07 Pre-Application Comments

07 Pre-Application
Comments and Design Response

08 Design Review Panel 01 - Presentation

Design Review Panel 02 - Desktop Review
Comments and Design Response

Superseded Pre-Application site plan with proposed footprint of current scheme overlaid in red

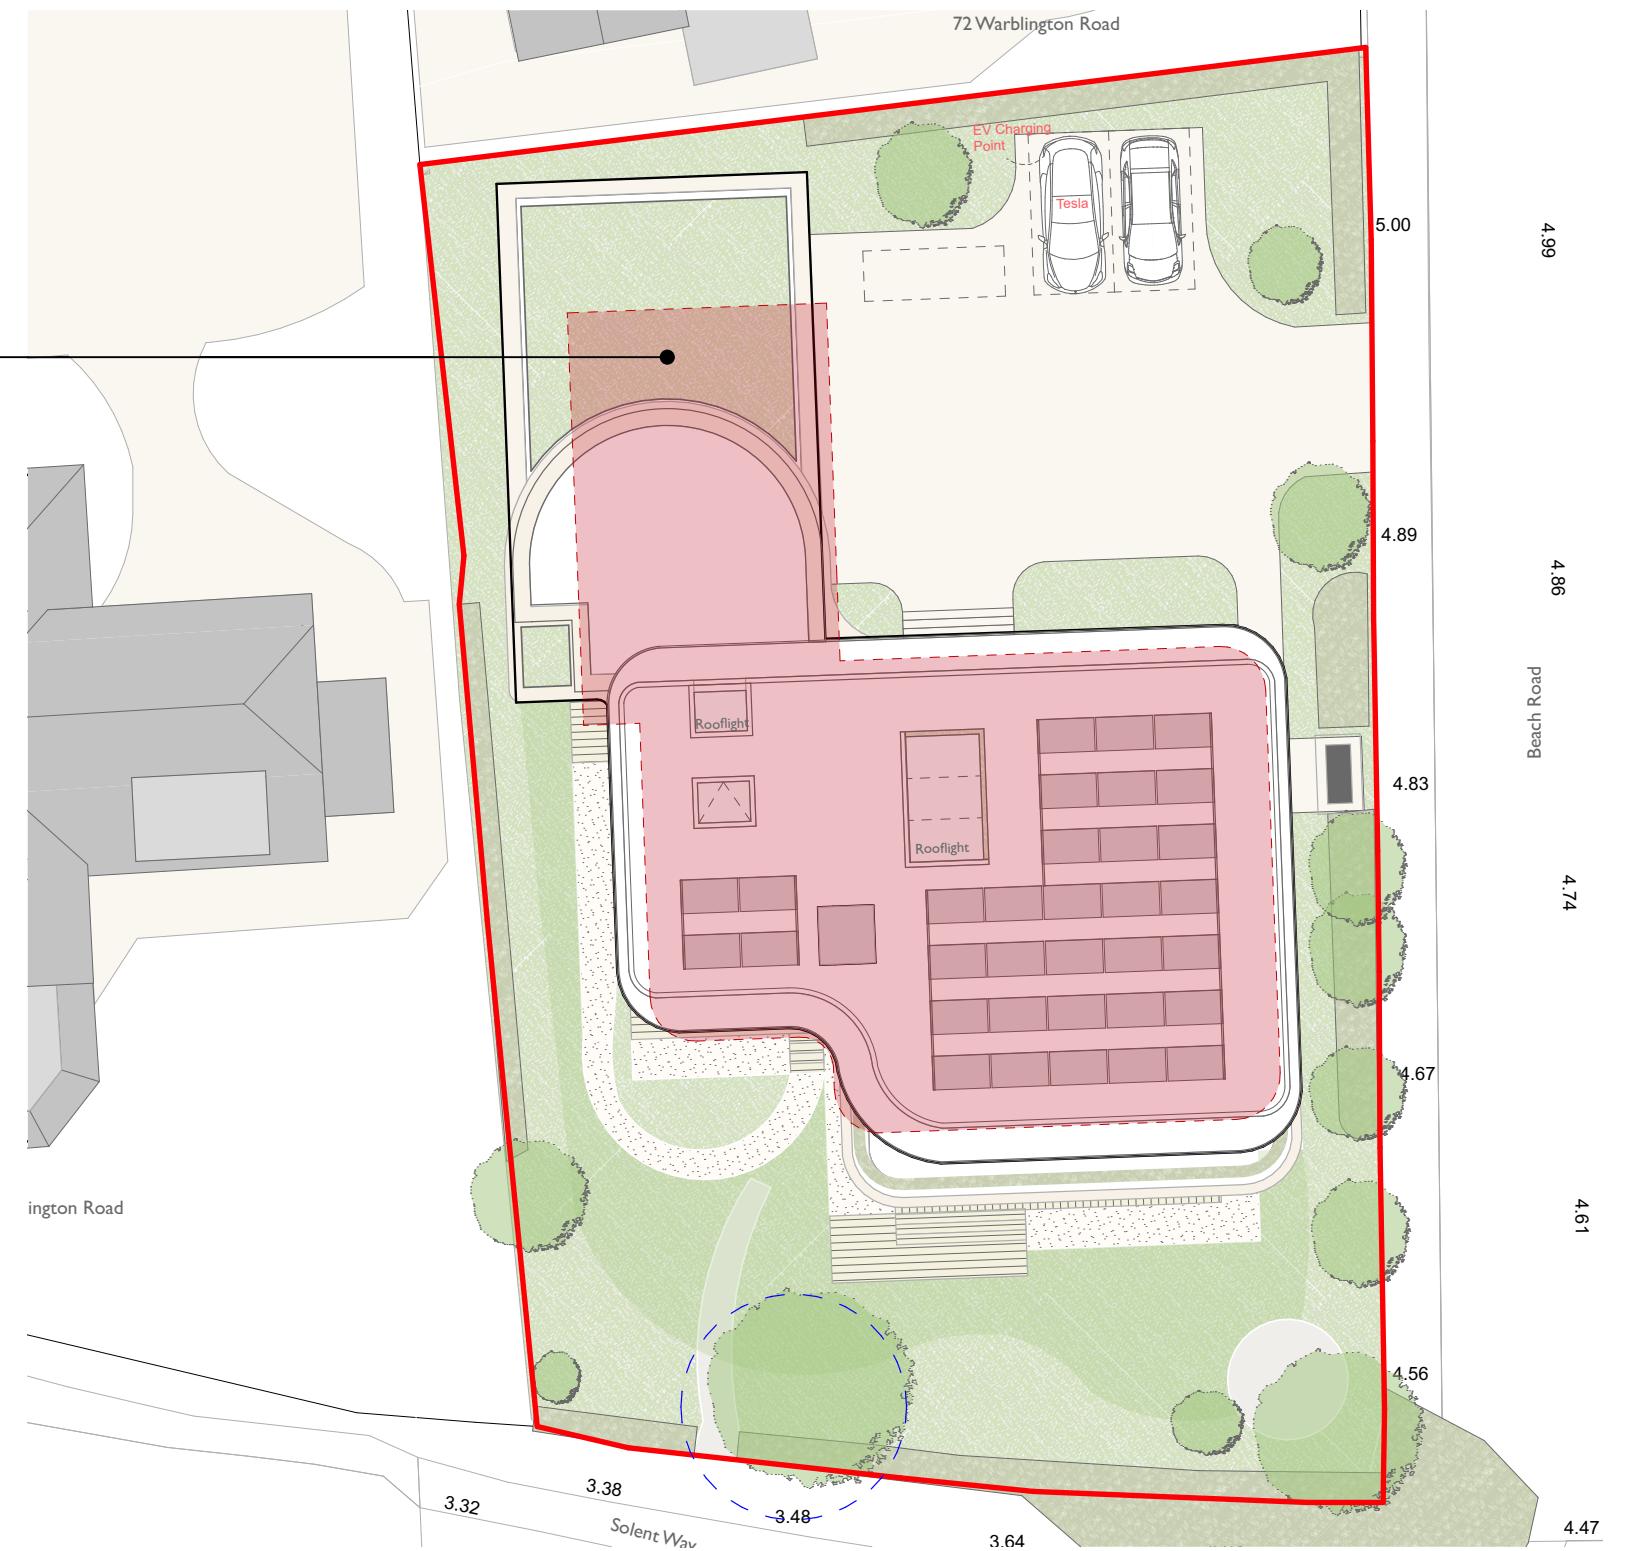
Pre-Application advice was requested from Havant District Council in September 2022 and comments were received on the 31st October 2022.

The pre-application response confirmed that the principle of replacing the dwelling is acceptable.

The red dashed line and fill on the site plan opposite illustrates the significantly reduced massing and footprint (-20%) of the current scheme, overlaid on the pre-application site plan.

red overlay denotes roof plan of current scheme (20% reduced)

A - 3D diagram illustrating reduction in massing

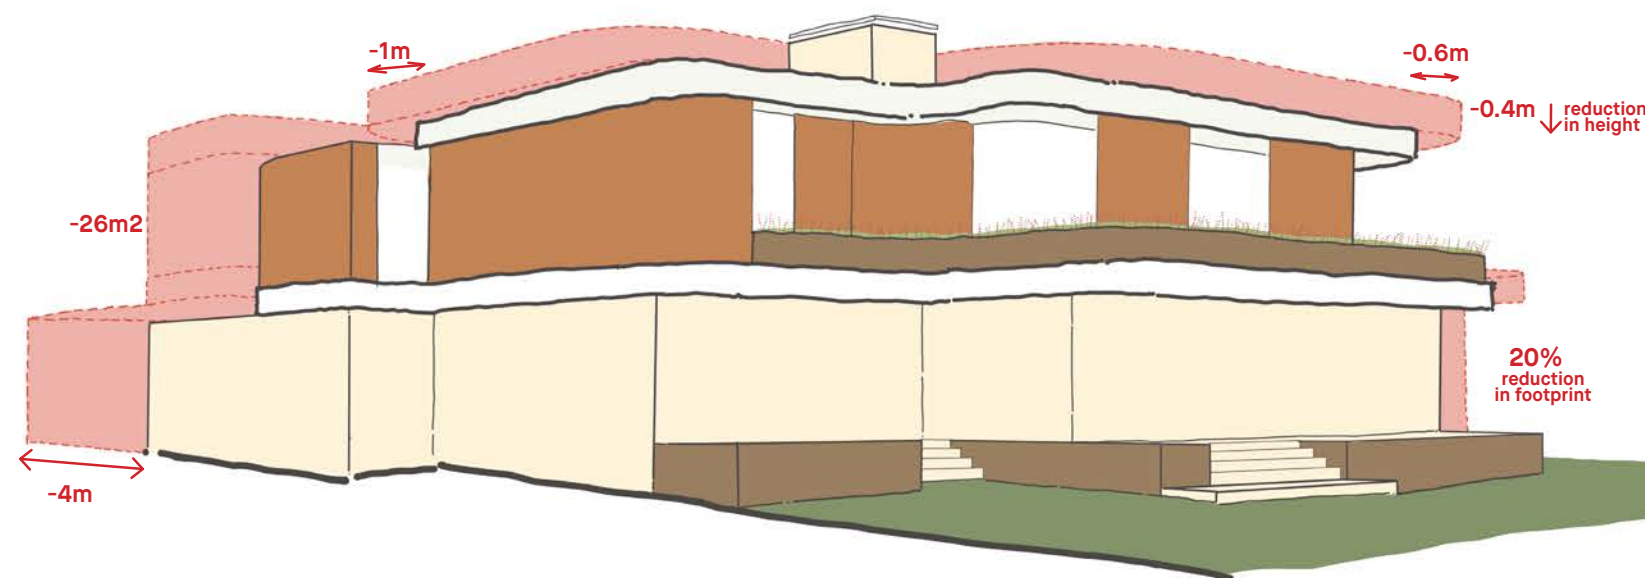
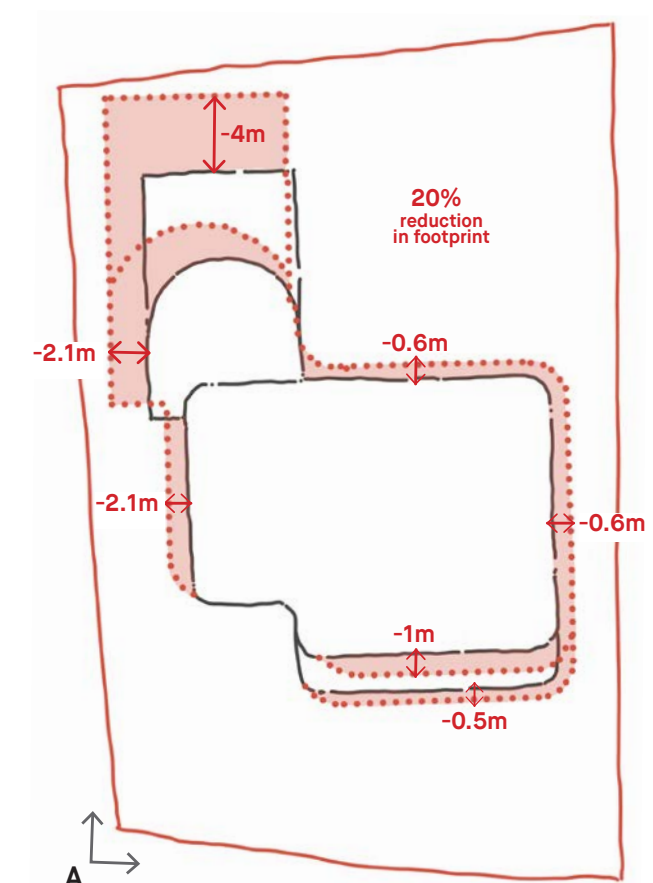
The proposed massing and footprint have been significantly reduced in response to the pre-application and DRP comments.

- The overall height has been **reduced by 0.4m**
- The footprint has been **reduced by 20%**
- The overall building width has been **reduced by 2.7m** and now matches the width of the existing dwelling on the site.
- The ground and first floor roof overhangs have been **reduced in all directions.**
- The garage has been **shortened by 4m**
